From: Williams, Anna <AWilliams@gibsondunn.com>
Sent: Monday, August 31, 2026 3:34 PM
To: Mark Sakioka; TAI, CARRIE; MCGILL, ANNA; CARON, MARTINA; HALLIGAN, MICHELLE; YEAGER, CHRISTOPHER
Cc: Forbes, Amy R.; ELesk; CMeany
Subject: RE: Sakioka Comment Timing
Attachments: Collector Streets (Reference)(6003229839.1).pdf; Costa Mesa - NWWAB - ZCA ODS Comments [8.31.26](6003236090.2).xlsx

Costa Mesa NWWAB - ZCA and ODS Review

Sakioke Property, Costa Mesa August 19, 2026

Figure 18

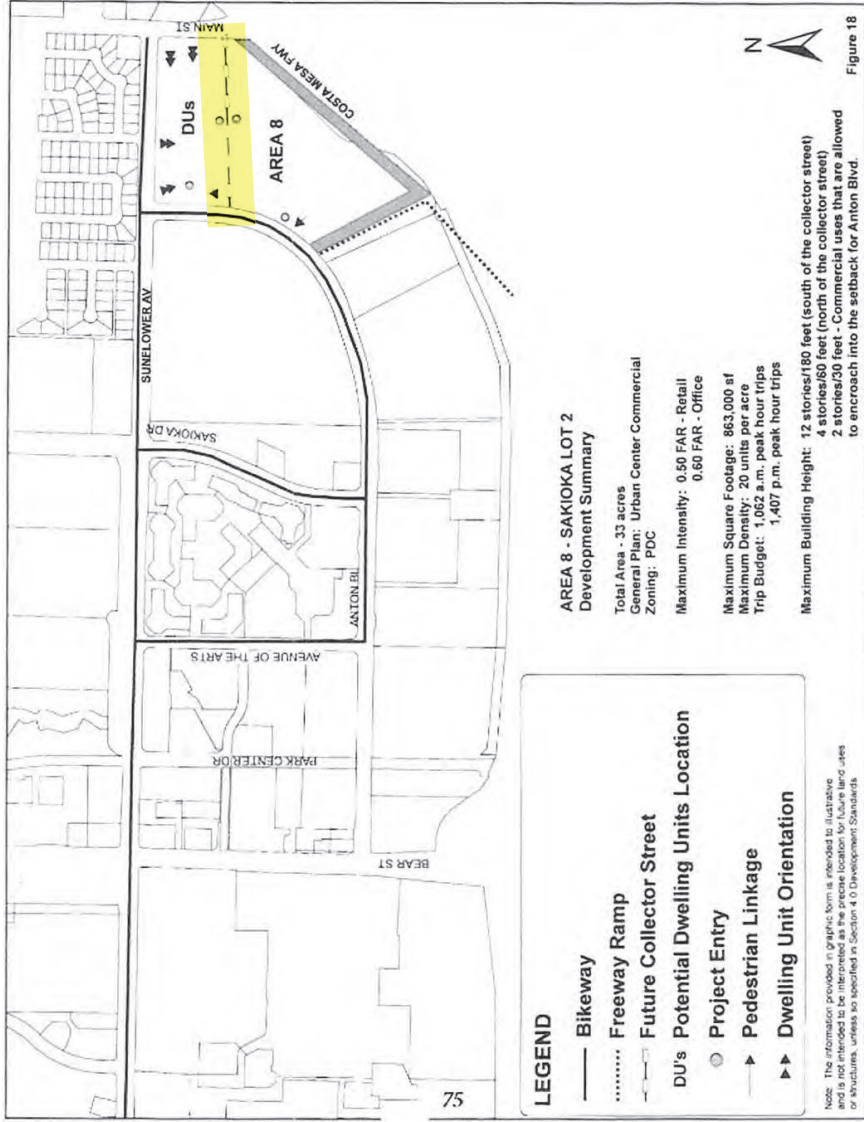
Incorrect Height Limit in NCMSP	180 height (/12 stories) max on Sakioke Lot 2 still shown in NCMSP and in SP references in GP elements.	Maximum height of 120 feet on Sakioke Lot 2 should be shown across GP, SP and other zoning code references. See separate PDF Sheets.	NCMSP	Figure 18 (Sakioke Lot 2 Development Summary)	General Plan consistency.
